METROPOLITAN GOVERNMENT OF NASHVILLE AND DAVIDSON COUNTY

STAFF RECOMMENDATION 1521 Woodland Street April 22, 2020

Application: New Construction—Infill and Outbuilding (DADU); Setback determination

Figure 1. Vacant lot at 1521 Woodland St.

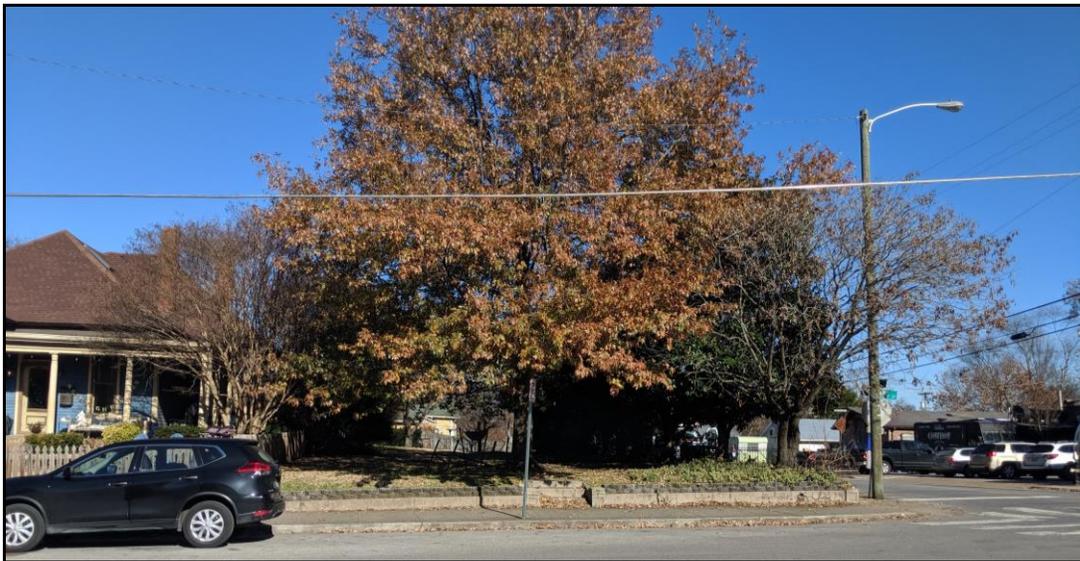
Background: The property located at 1521 Woodland Street is a vacant lot located at the northwest corner of North 16th Street and Woodland Street (Figure 1). At forty-seven feet, six inches (47'-7") wide, the lot is one of the narrower lots on this block of Woodland Street. The Commission disapproved a proposed two-story infill at this location in December 2019. The revised plan is for a one and one-half story design.
